COUNCIL ASSESSMENT REPORT

SYDNEY CENTRAL CITY PLANNING PANEL

PANEL REFERENCE & DA NUMBER	PPSSCC-400 - DA 730/2023/JP
PROPOSAL	Educational Establishment for 80 Students and 30 Staff and Associated Works.
ADDRESS	Lot 10 DP 1286147, 95 Fontana Drive Gables
APPLICANT	Autism Spectrum Australia (Aspect)
OWNER	Minister For Early Education and Early Learning and AW Bidco 4 Pty Ltd
DA LODGEMENT DATE	20 October 2022
APPLICATION TYPE	Development Application – Integrated
REGIONALLY SIGNIFICANT CRITERIA	Clause 5, Schedule 6 of the Planning Systems SEPP: Private Infrastructure and Community Facilities with a CIV of more than \$5 million
CIV	\$5,208,209.00 (excluding GST)
CLAUSE 4.6 REQUESTS	Nil
KEY SEPP/LEP	Transport and Infrastructure SEPP Resilience and Hazards SEPP Industry and Employment SEPP Biodiversity and Conservation SEPP The Hills LEP 2019 The Hills DCP 2012
TOTAL & UNIQUE SUBMISSIONS KEY ISSUES IN SUBMISSIONS	Nil
DOCUMENTS SUBMITTED FOR CONSIDERATION	Architect: EJE Architecture Town Planner: DFP Planning Consultants Landscape Architect: Terras Landscape Architects Bushfire: Peterson Bushfire Expert Consulting Services Engineering: Adams Engineering Quantity Surveyor: Mitchell Brandt

ATTACHMENT F – FLOOR PLANS

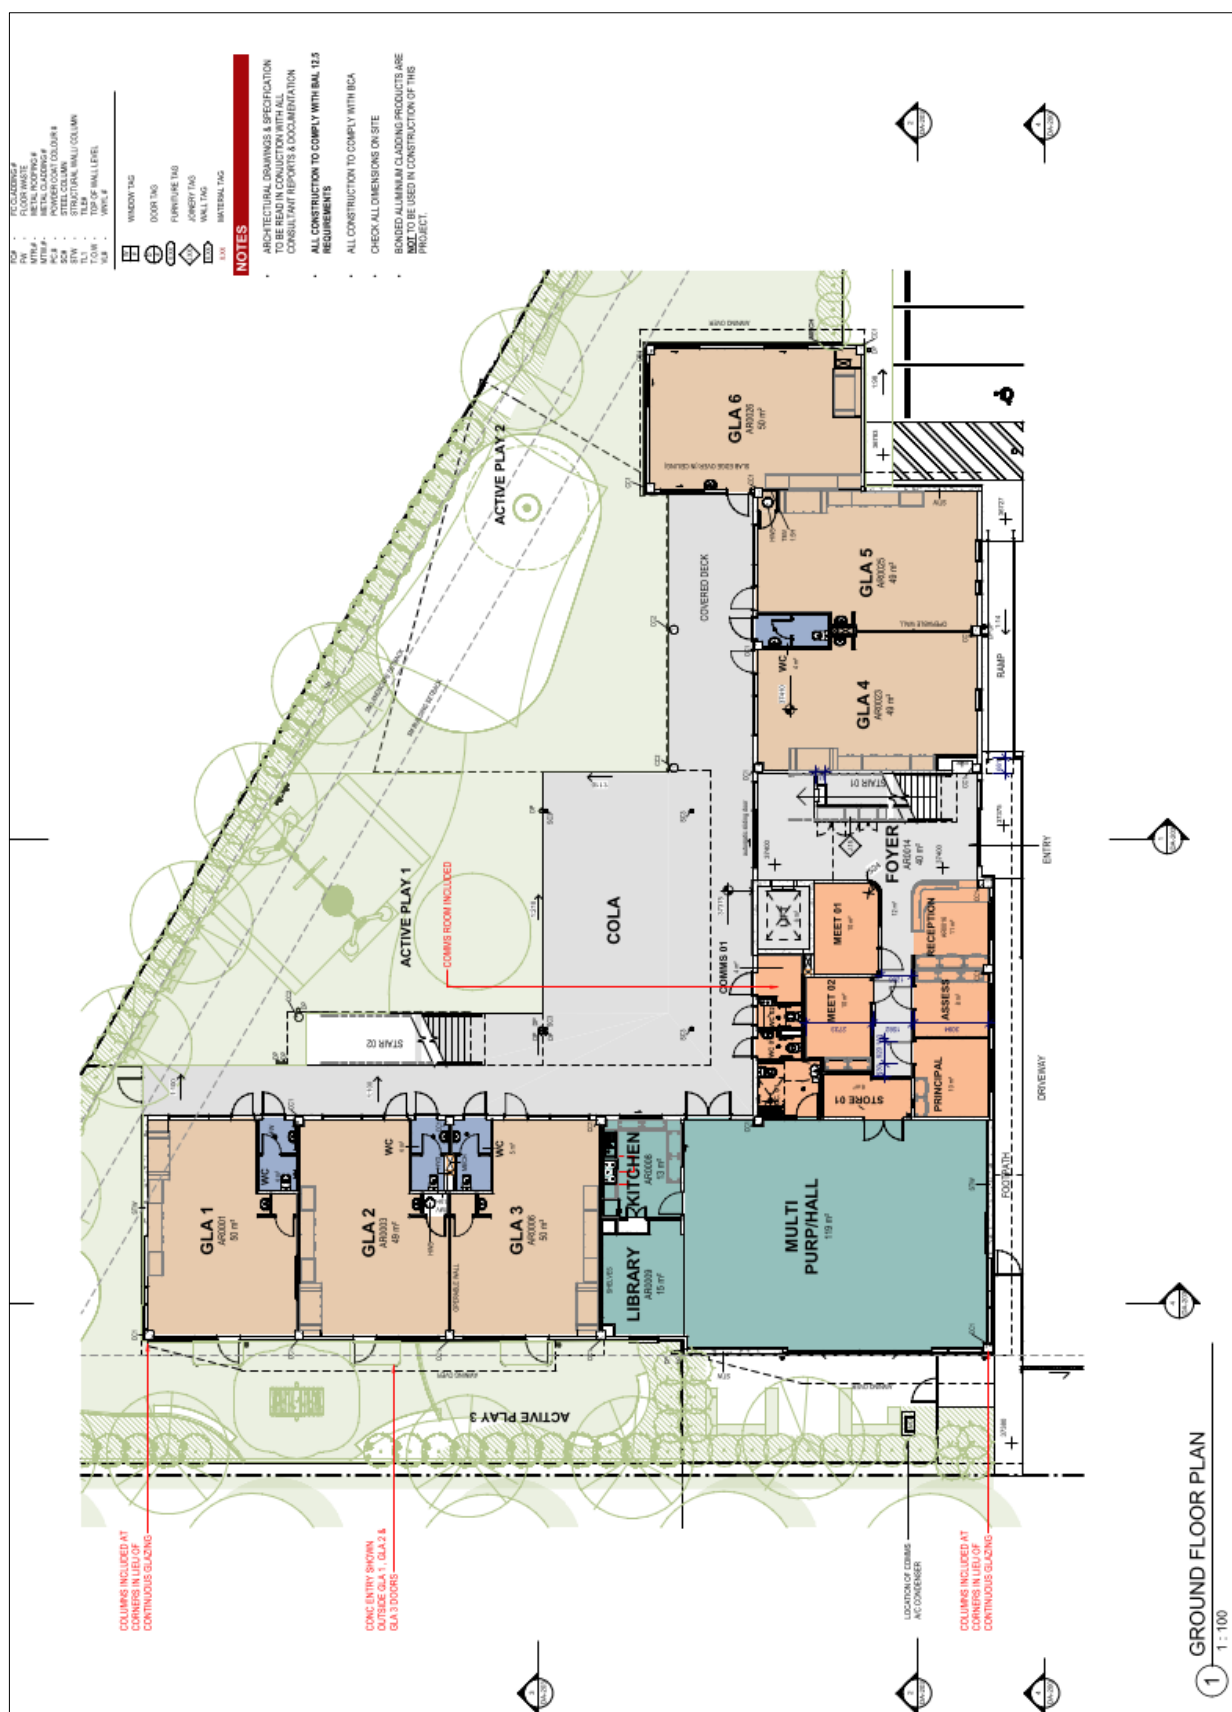
The boundary fence of Play Area 3 adjacent to Fontana Drive is to be made solid and gap free so as to act as an acoustic barrier. It must be set back 600mm from the property boundary. Screen planting to be provided as per Condition 5.

autism spectrum australia - the gables box hill

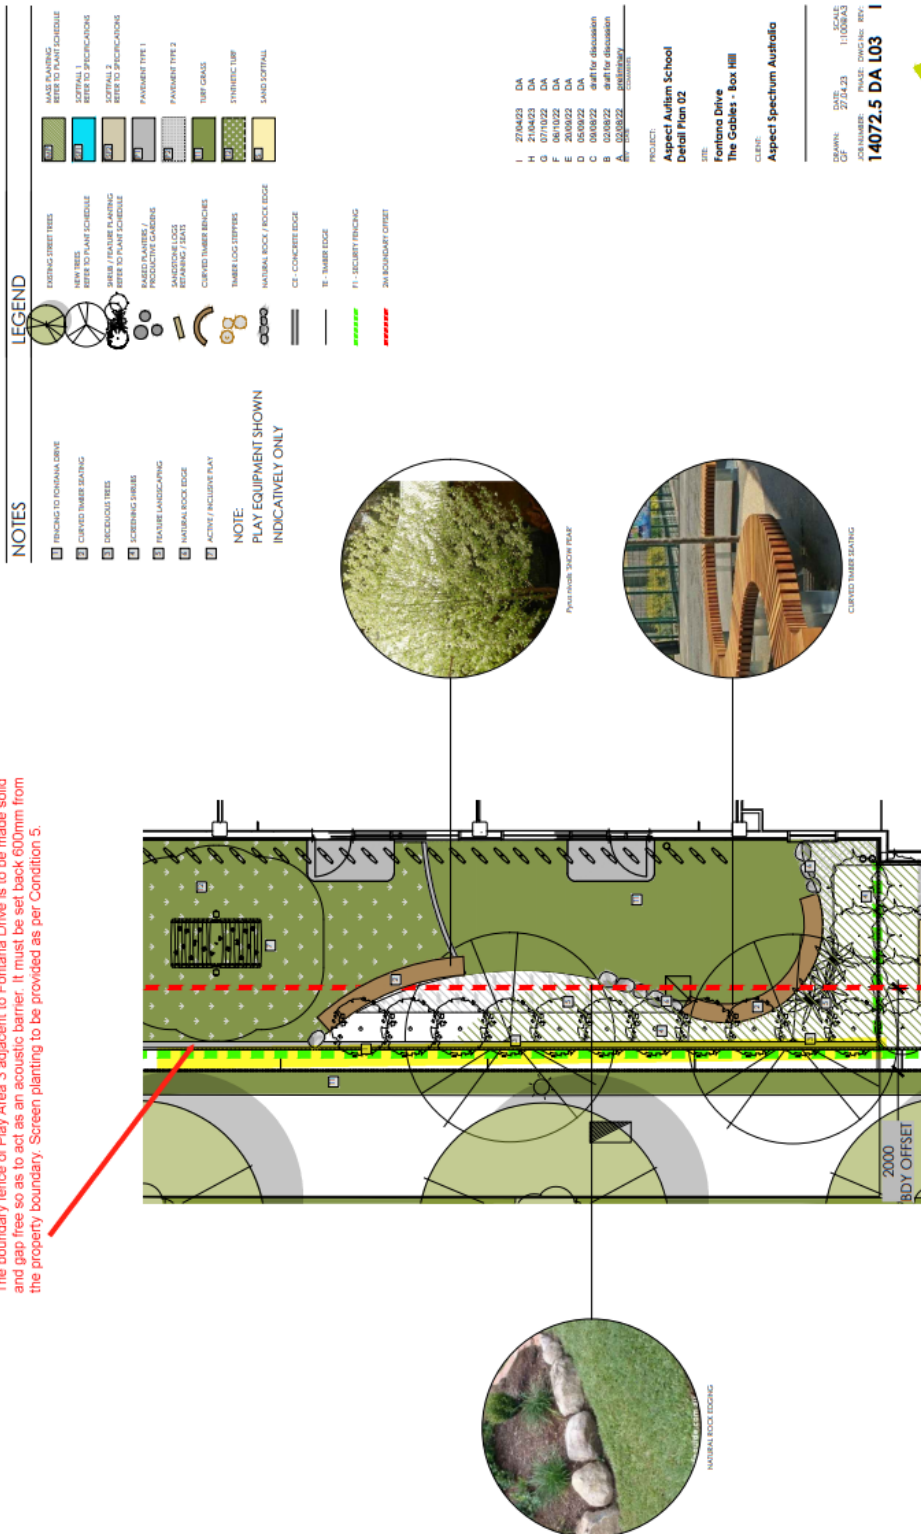
The boundary fence of Play Area 3 adjacent to Fontana Drive is to be made solid and gap free so as to act as an acoustic barrier. It must be set back 600mm from the property boundary. Screen planting to be provided as per Condition 5.

autism spectrum australia - the gables box hill

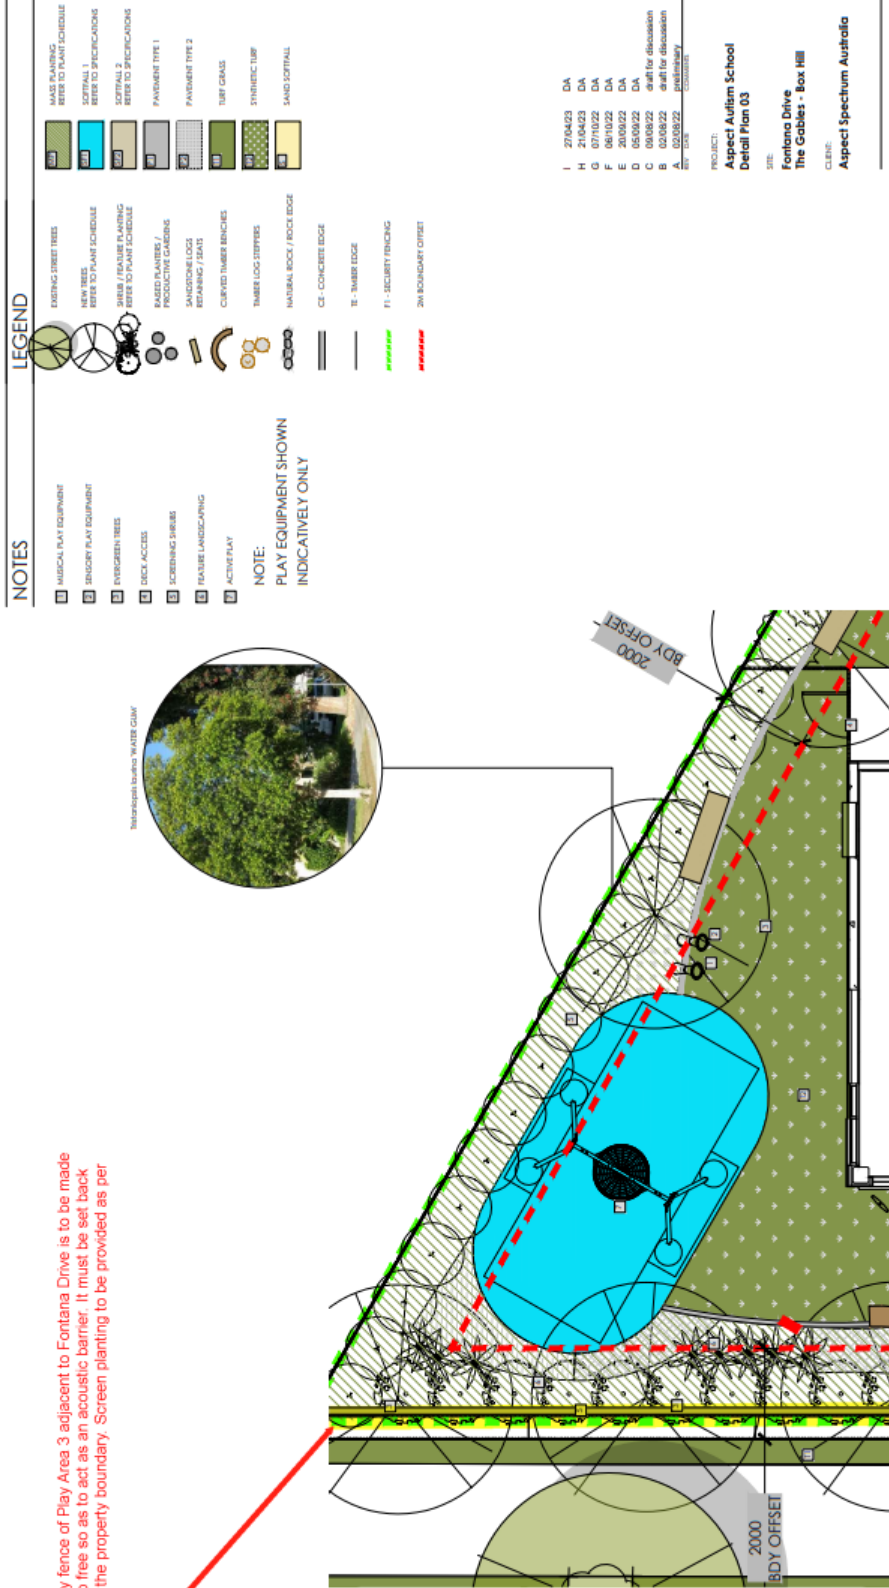
The boundary fence of Play Area 3 adjacent to Fontana Drive is to be made solid and gap free so as to act as an acoustic barrier. It must be set back 600mm from the property boundary. Screen planting to be provided as per Condition 5.
